**SUPPLEMENTAL ENGINEERING GEOLOGIC STUDY**  
***Onsite Wastewater Treatment System (OWTS)***  
Proposed Single-Family Residential Development  
634 Palomar Drive  
Redwood City, California

**RE: SUPPLEMENTAL ENGINEERING GEOLOGIC STUDY**  
***Onsite Wastewater Treatment System (OWTS)***  
Proposed Single-Family Residential Development  
634 Palomar Drive  
Redwood City, California  
**ATLAS #91-55905-C (3067)**

In accordance with our Agreement, we have prepared this letter report in reply to the June 14, 2021 geotechnical peer review letter prepared by Cotton, Shires and Associates, Inc., on behalf of the Environmental Health Department's feasibility assessment of the proposed OWTS (aka, Leachfield) associated with your proposed development at the property in Palomar Park referenced above (Plate 1, *Vicinity Map*, Figure 1; Plate 2, *Site Plan, Cross Section A-A'*). This report follows the April 29, 2019 engineering geologic report by Geosphere Consultants, Inc., and our July 29, 2020 geotechnical update report for the proposed development.

## REPLY TO PEER REVIEW COMMENTS

Job No.: 91-55905-C	<b>SITE PLAN,          CROSS SECTION A-A'</b> 634 Palomar Drive Redwood City, California	<b>Plate          2</b>
	Approved: JEB		
	Date: 09.27.2021

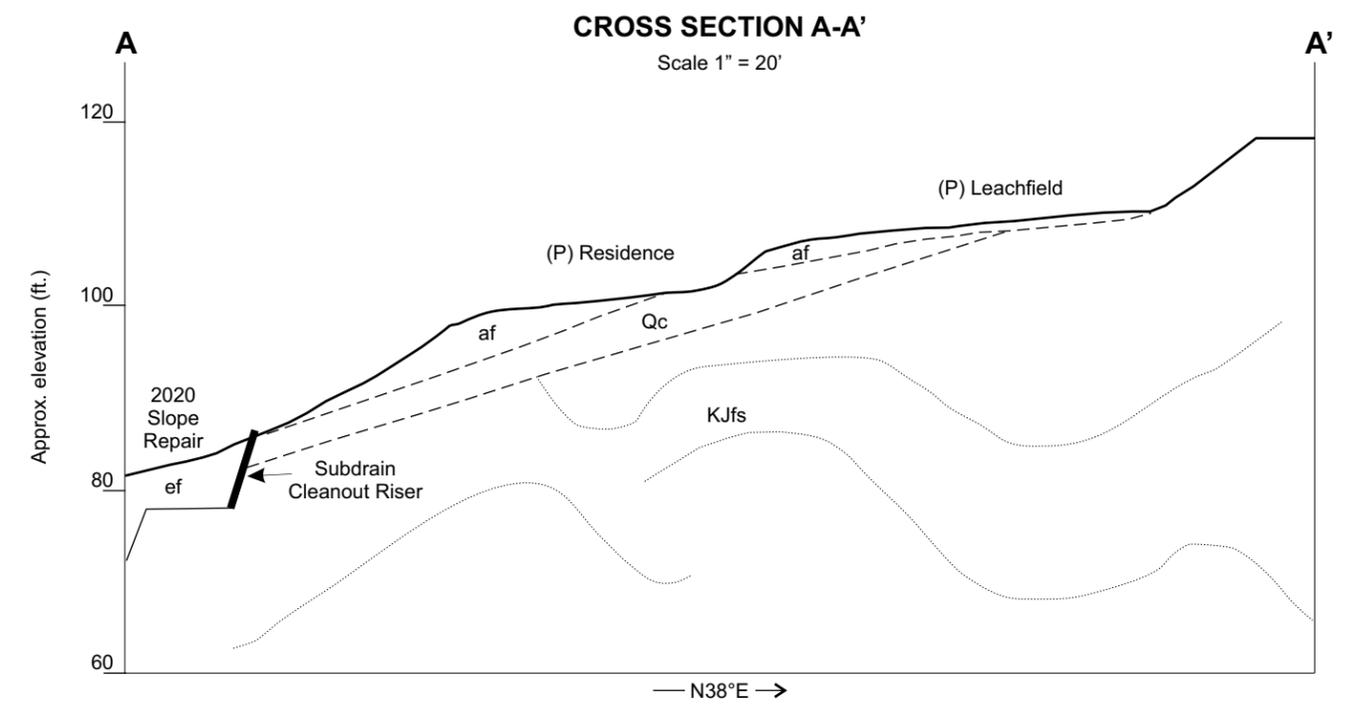
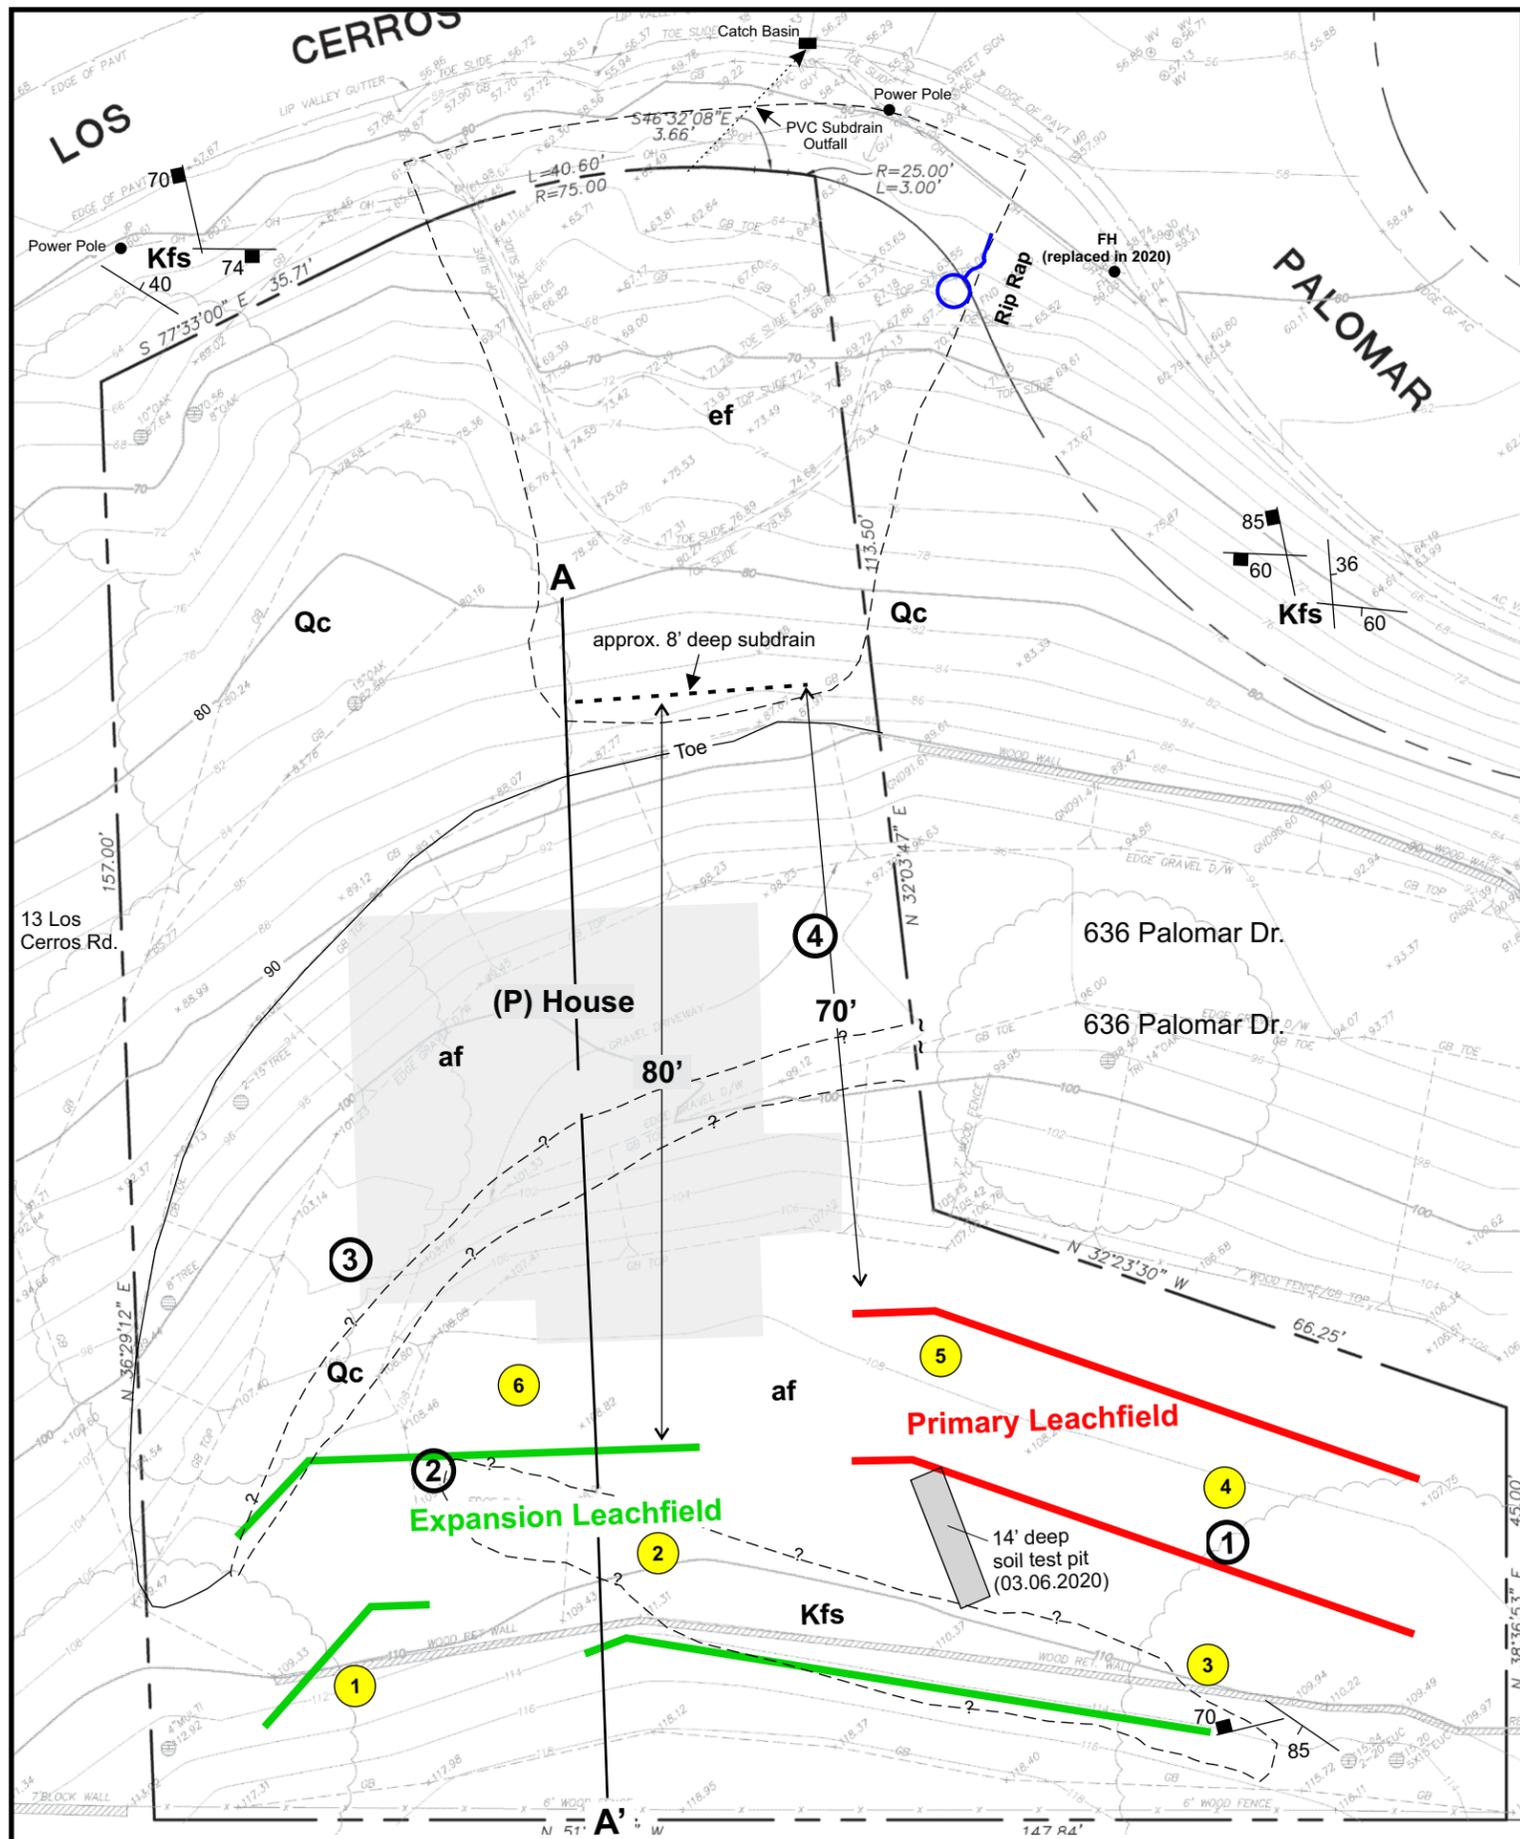
**a) The Project Engineering Geologist should discuss and clarify the natural and proposed slope gradients in the vicinity of the proposed primary and expansion leachfield lines. They should also clarify whether all existing undocumented fill will be removed or replaced as engineered fill as part of proposed construction. If existing natural slopes or proposed final grades surrounding the OWTS are steeper than 35 percent, then we understand a slope stability analysis will be required. If a slope stability analysis is found to be necessary, we recommend completion of additional subsurface borings extending confidently below the elevation of proposed site improvements (e.g., excavations for the residence and foundations, and OWTS, etc.) to collect supplemental samples, laboratory testing to determine accurate shear strengths and unit weights of the soil and bedrock materials, and further evaluate other geotechnical or geologic site conditions (e.g., groundwater/phreatic surface, etc.).**

**b) The Project Engineering Geologist should discuss the earth materials anticipated to be encountered during OWTS construction (e.g., undocumented fill, expansive colluvium, hard bedrock, etc.). The Consultant should clarify whether proposed leach line excavations, as proposed, will extend below surficial colluvium encountered at the site. We note the reported layers of high plasticity soils along the bedrock/colluvium contact. The applicant's Consultant should evaluate whether additional percolation testing or pits are appropriate to document the applicable percolation rates of earth materials at depth. The location of the prior 14-foot-deep pit advanced in November of 2000 should be clarified on project plans or within a figure provided by the applicant's Engineering Geologist. The Project Engineering Geologist should evaluate whether the depth of high groundwater at the site is a minimum of 5 feet below the base of the proposed OWTS excavations.**

Four additional borings were sampled to further evaluate the earth materials to a depth of 19 feet (Appendix A). In the proposed leachfield area, Borings 1 and 2 encountered hard, mainly closely fractured greywacke thinly interbedded in Boring 1 with Clayey Sandstone and Shale breccia. Borings 3 and 4, in the dirt road leading up to the proposed leachfield, encountered 4½ to 7 feet of surficial soil composed of dense to very dense Silty SAND with Gravel, and Gravelly SAND fill mantling approximately 2½ feet of medium dense, Clayey SAND colluvium over greywacke bedrock. Ground water was not encountered. The surficial soils were generally moist.

The supplemental subsurface exploration and surface mapping revealed competent sandstone to be underlying the proposed leachfield. Sandstone exposed in the cut slope above Boring 1 exhibited a favorably steep inclination relative to slope stability, and steep closely spaced jointing relative to optimum OWTS performance over the project lifetime (Plate 2).

In addition, we judge the proposed OWTS presents a **Low Risk** for contaminating water quality in the site slope repair subdrain system adequately located approximately 70 feet downslope from the Primary Leachfield (PL) and approximately 80 feet from the Expansion Leachfield (EL) (Plates 2 and 3). Similarly, the proposed PL and EL are respectively located approximately 170 and 102 feet from the southern margin of the slope repair subdrain system spanning 13 Los Cerros into 738 Loma Court (Plate 3).

**GEOMORPHIC MAP,  
 CROSS SECTION X-X'**  
 634 Palomar Drive  
 Redwood City, California

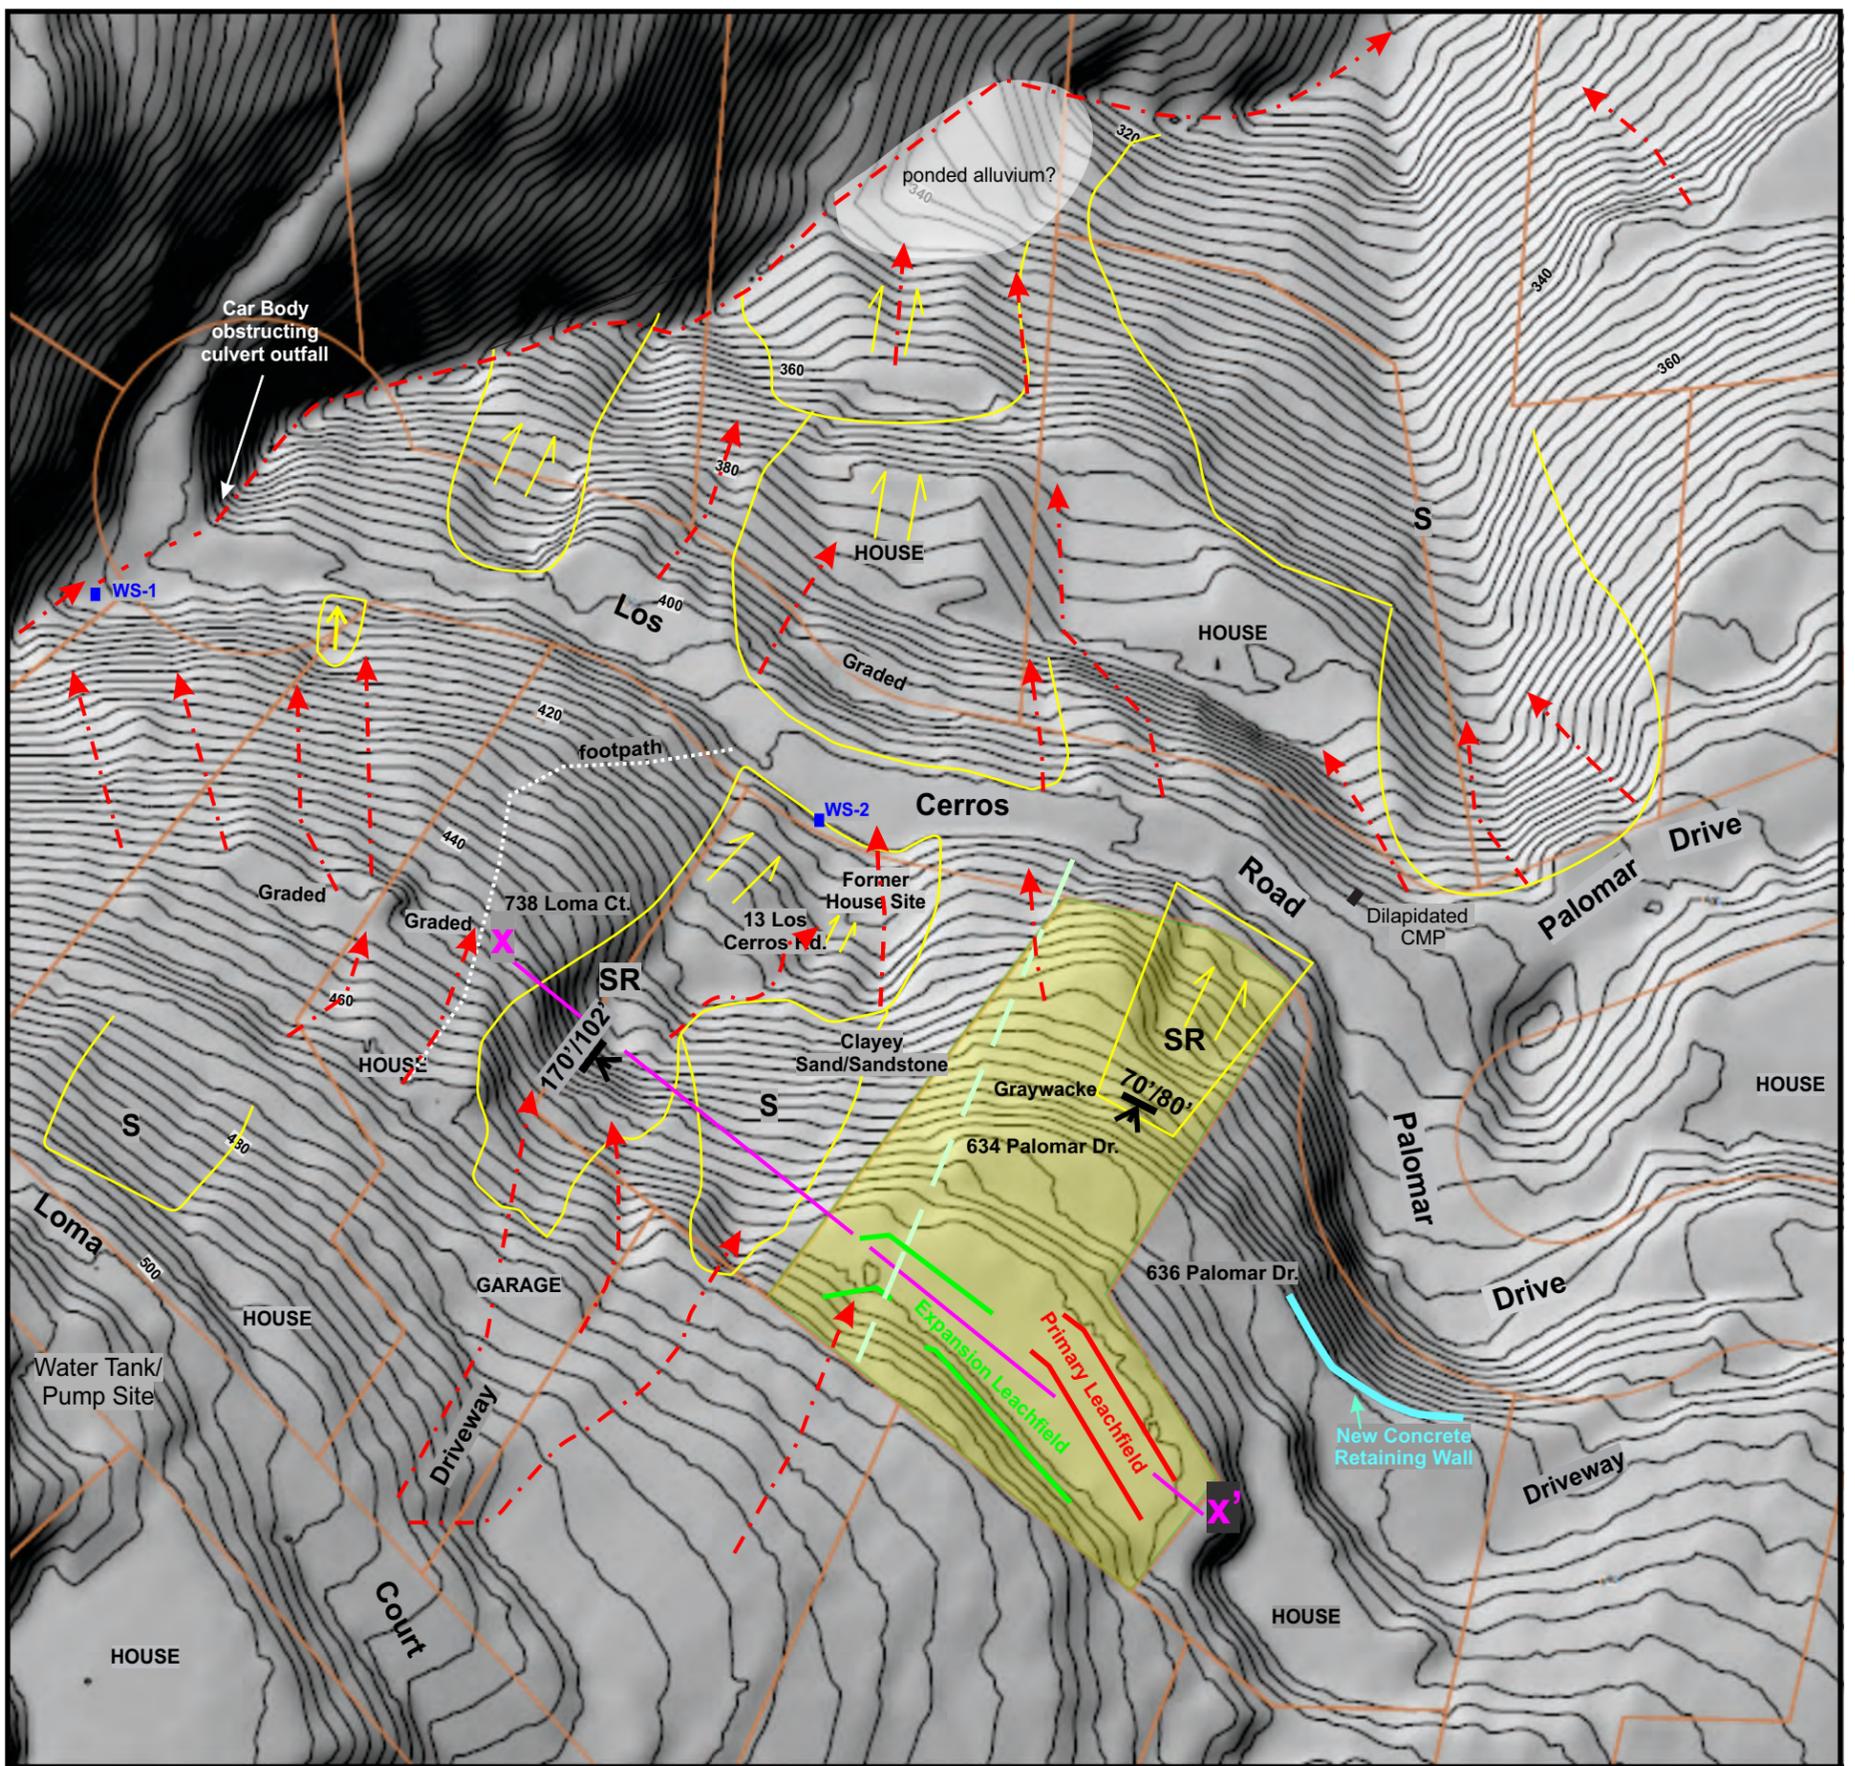
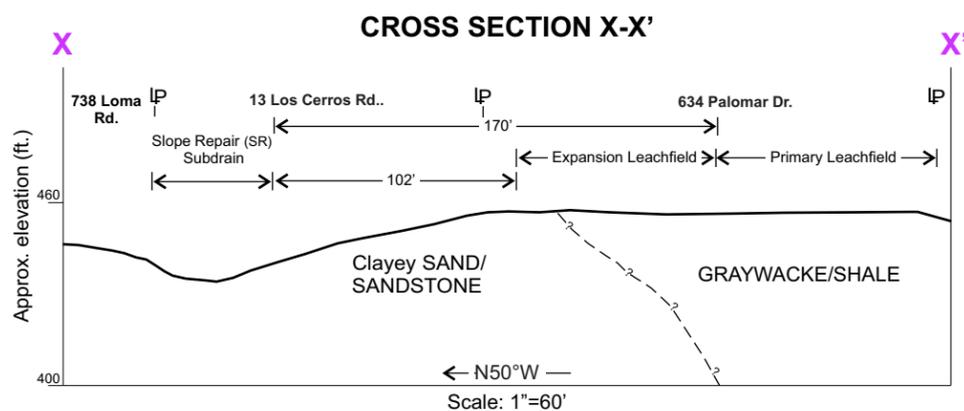
**e) Typically, OWTS are set-back 100 feet from areas identified as landslides unless otherwise recommended or found appropriate by a Certified Engineering Geologist. We recommend the Project Engineering Geologist process and review hillshade topographic maps derived from publicly available LiDAR data-sets as well as review the results of their previous research to determine areas surrounding the site that have been subject to landsliding and subsequently clarify appropriate set-backs, as necessary.**

There are no unmitigated landslides within 100 feet of the proposed OWTS (Plate 3). In our opinion, existing OWTS setbacks are sufficient.
